RAI No.	Section	Issue	Regulatory Link	Discussion	Path Forward
CH-10	Section 5.2 Waste Characterization, Section 6.4 of HDP-TBD-WM-906	Portion of Area 1 that is excluded	10CFR20.2002(a)	The northeast portion of Area 1 and Area 5 will be excluded from this request, but the exact boundary and methods for keeping the materials from intermixing with materials that will be sent to USEI are not described.	Provide a detailed description (e.g., enlarged map with discernable boundaries) that delineates the boundaries of the areas that will be excluded from this request. Describe the procedures for ensuring that the excluded wastes will not be intermixed with other wastes prior to shipment.

RAI No.	Section	Issue	Regulatory Link	Discussion	Path Forward
CH-13	Section 6	MicroShield ®[1] modeling of worker dose	10CFR20.2002(d)	Some of the parameters used in the MicroShield calculations for the worker dose differ from those used by Westinghouse in the May 2009 20.2002 request and it is not clear why: • The orientation of the excavator and the stabilization workers in relation to the gondola is different in this request • The shield is used for determining buildup in the excavator and stabilizatio

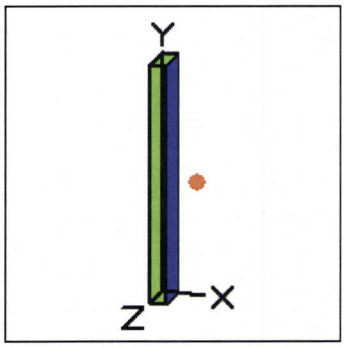
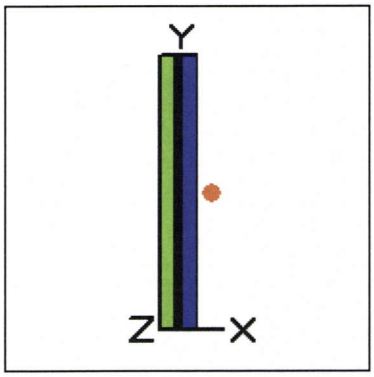
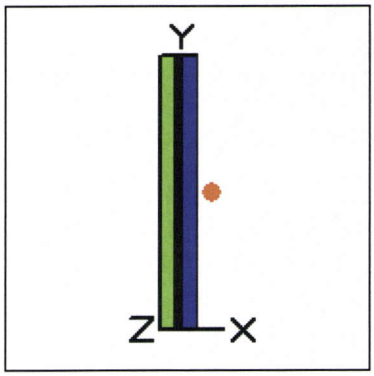
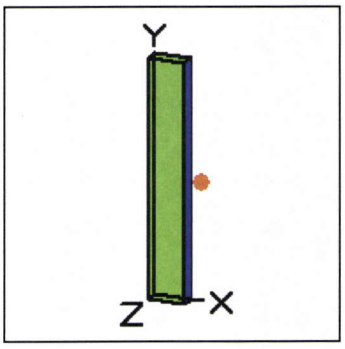
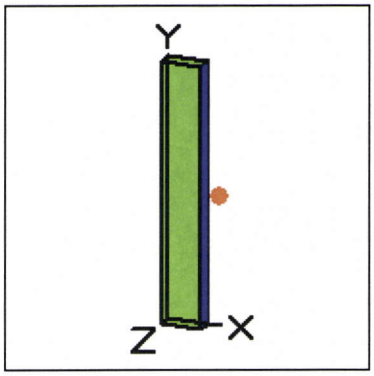
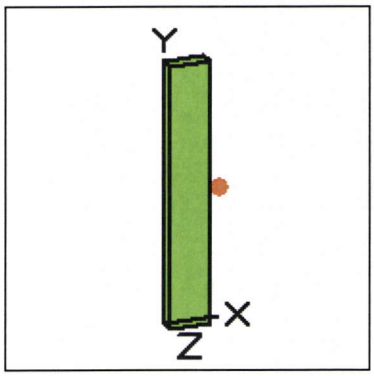
The orientation of the excavator and the stabilization workers in relation to the gondola is different in this request

The shield is used for determining buildup in the excavator and stabilization worker scenarios in the current request, while the source was used for buildup in the previous request

The orientation of the excavator and the stabilization workers has been revised to be consistent with the initial request. See response pertaining to source buildup below.

The source is the more appropriate selection for the buildup material based on the number of mean free path (MFP) lengths associated with

RAI No.	Section	Issue	Regulatory Link	Discussion	Path Forward
				it as compared to the shield. The use of the shield for building up in the current submittal is erroneous. Dose factors for the excavation operator (using the source as the buildup material) were recalculated (MicroShield results attached). This recalculation also includes a modification to the exposure geometry for the excavation / stabilization operator, gondola surveyor and transportation worker. In the original submittal the dose points for each of these scenarios were placed on the incorrect plane. These changes result in a decrease in the external exposure to the transportation worker and gondola surveyor and a slight in increase in dose to the excavator operator / stabilization worker. The increase in external dose to the excavation operator (9.4E-4 mrem/yr to 2.7E-3 mrem/yr) is insignificant in comparison to the accompanying internal dose which is assigned (1.8E-1 mrem/yr). The increase in dose to the stabilization operator is also insignificant (3.14E-5 mrem/yr to 9.13E-5 mrem/yr) when compared to the assigned internal dose (6.11E-3 mrem/yr). *The thickness of the shielding for the gondola surveyor is less in the current request (0.794 cm) than in the previous one (2.53 cm)* The shield thickness for the gondola surveyor in the current request is based on the thickness of the railcar wall (0.794 cm) as opposed to the prior request in which the same shielding was afforded the surveyor as the excavator operator. The assumptions in the current request more accurately reflect the actual conditions in which the surveyor is oriented to the side of the car and the excavation operator is above the car. The one inch shielding afforded the excavation operator is based on the deck thickness for the excavation gantry. Dose factors for the gondola surveyor and excavator operator for the prior 20.2002 request were also recalculated (MicroShield results attached). There is a slight increase in external dose to the gondola surveyor (1.2E-3 mrem to 2.5E-3 mrem) and a slight decrease in external dose to the excavator operator (8.4E-4 mrem to 4.2E-4). These changes do not change the results of the assessment which reported the dose to the truck driver (which is unaffected by these changes) as bounding. *Westinghouse should provide justification for the assumed source shape in the Hematite analysis versus the cube shape assumed for other disposals at USEI* The difference in source shape in the external dose model used for the stabilization operator is due to the use of gondola railcars for waste shipment by HDP versus trucks by other applicants.

Figure 1, Sensitivity Analysis – Shipping Rate versus Post-Closure Dose.

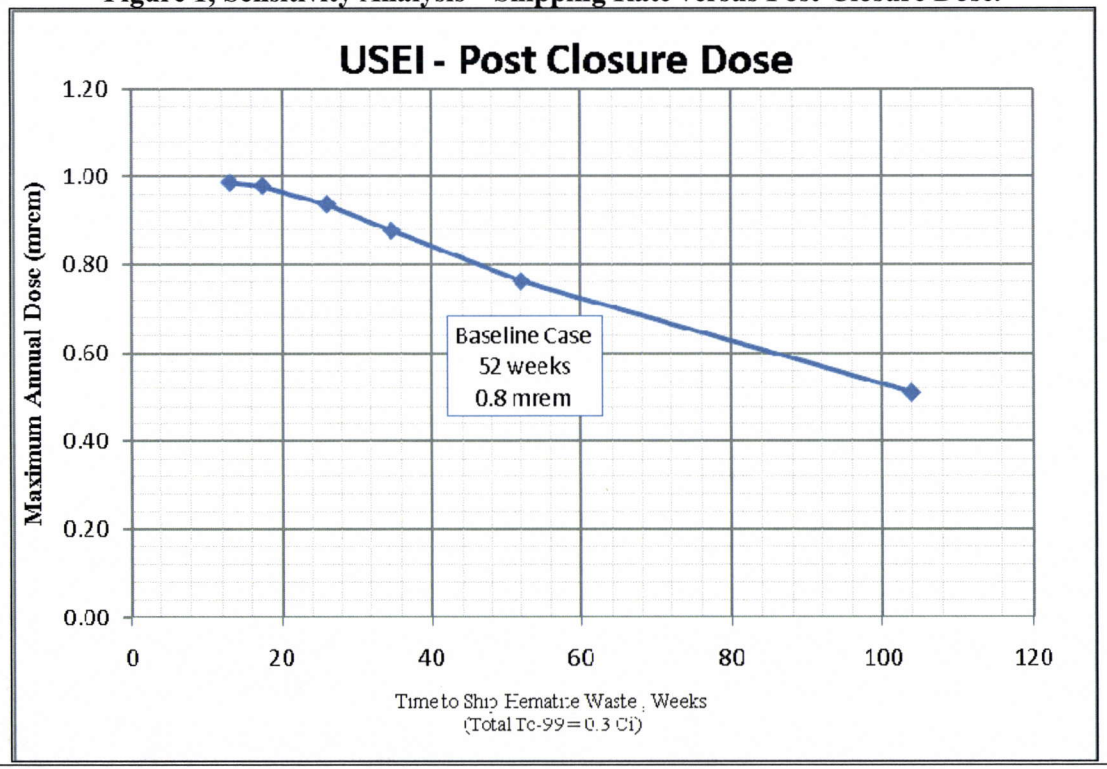
RAI No.	Section	Issue	Regulatory Link	Discussion	Path Forward
CH-21	Section 7.4 Sensitivity Analysis, Attachment 4	Sensitivity Analysis for Post Closure Dose	10CFR20.2002(d)	The sensitivity analysis describes a 13 week scenario where the dose is 1.6 mrem, but in Attachment 4, the dose for13 weeks is approximately 0.99 mrem.	Please describe the reason for the difference in reported doses.

Response Summary: Attachment 4 to Enclosure 1 to HEM-12-2 contains the correct information.

Response Detail: The figure and associated text in Section 7.4 of Enclosure 1 to HEM-12-2 do not reflect the data in Attachment 4 to Enclosure 1. The corrected figure is presented below, along with a revision to the last sentence of the second paragraph in Section 7.4 of Enclosure 1.

As shown in this Figure, the post closure dose increases only slightly as the shipment time decreases, remaining below 1.0 mrem for a 13 week duration.
